**THREEMILE CANYON FARMS
INLAND AREA AR LIMITED LICENSE
APPLICATION**

Threemile Canyon Farms, LLC

application
amendments

Figure D-4
Inland Wells Schematic Cross Section

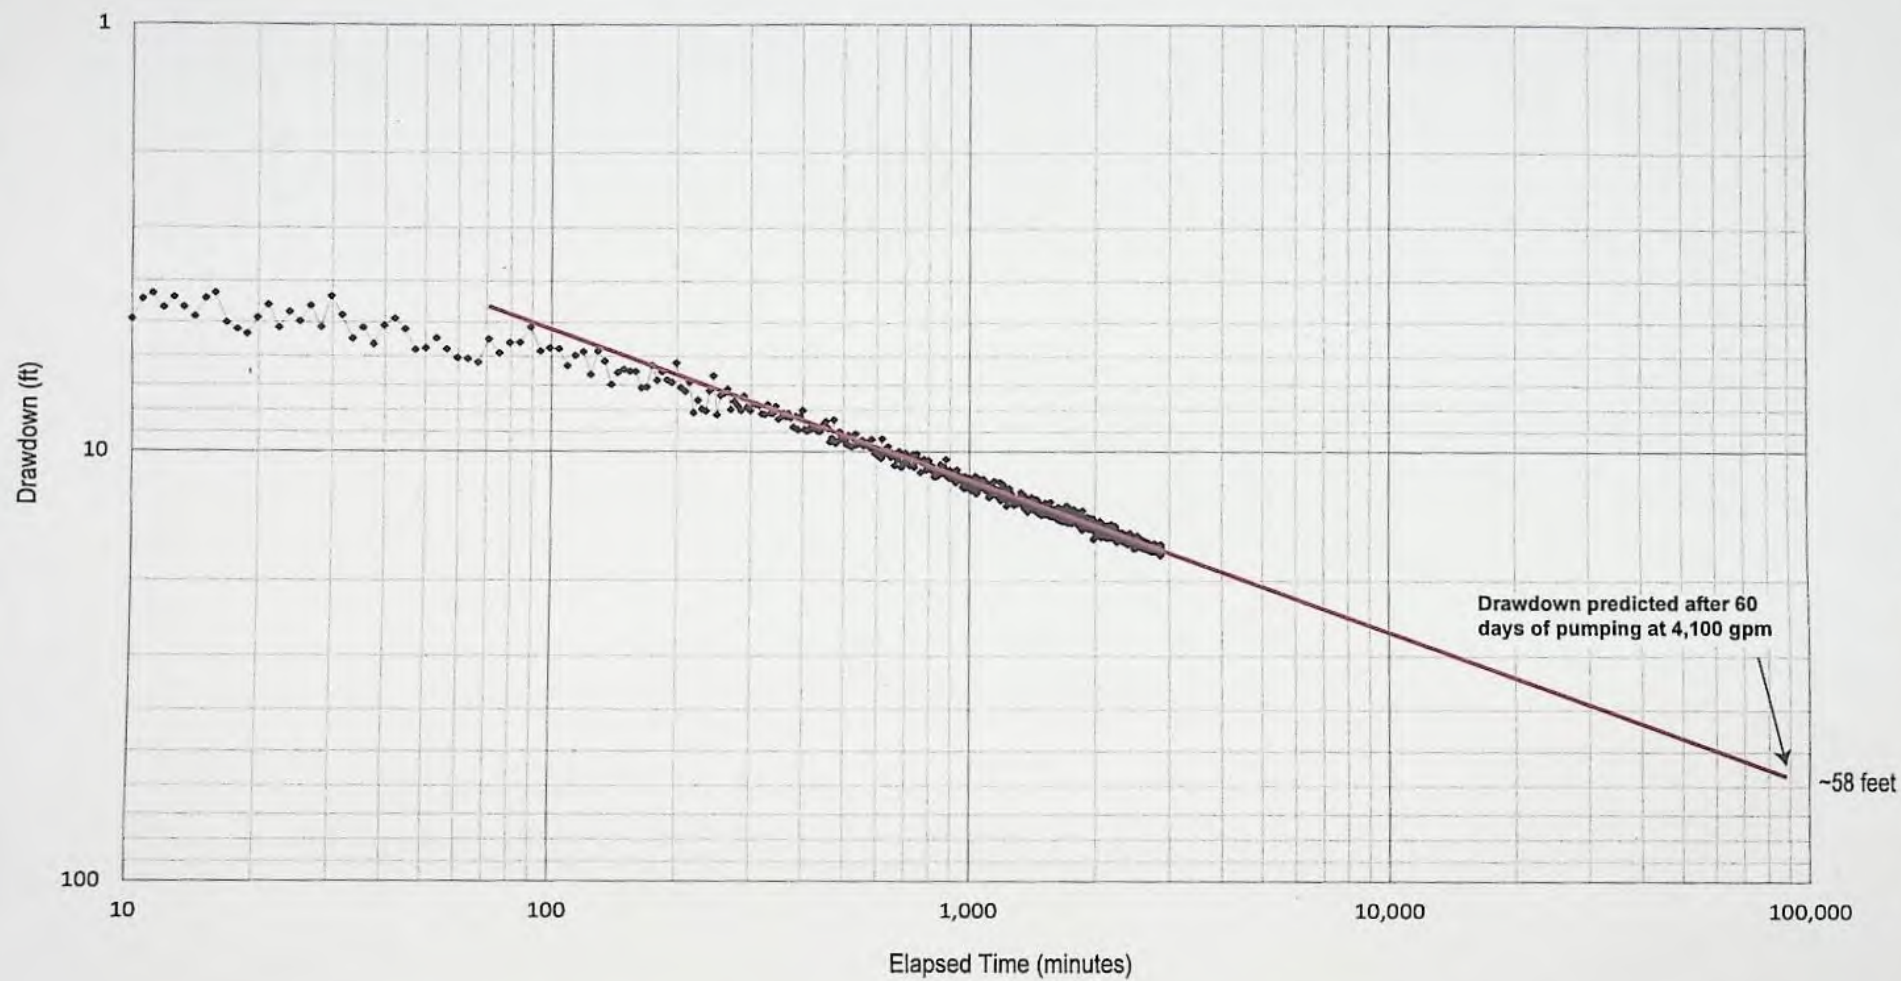
- Attachment D is interpreted as the report intended to meet 690-350-120(3)(f). It provides a description of the geology, and some hydrogeologic features, but it lacks a conclusion that the project is hydrologically feasible as required by rule. In other words, what about the geology and hydrogeology leads to the conclusion that 10,000 acre-feet can be stored annually? The following additions will help build that case:
- To describe the groundwater conditions prior to AR, provide a comprehensive hydrograph showing the long-term water level data associated with proposed AR wells and the dedicated observation well.
- Please provide the aquifer test (D-5) data plotted on a semi-log scale in addition to the log-log scale.
- Regarding Figure D-4, is it possible to include all six project wells instead of three?
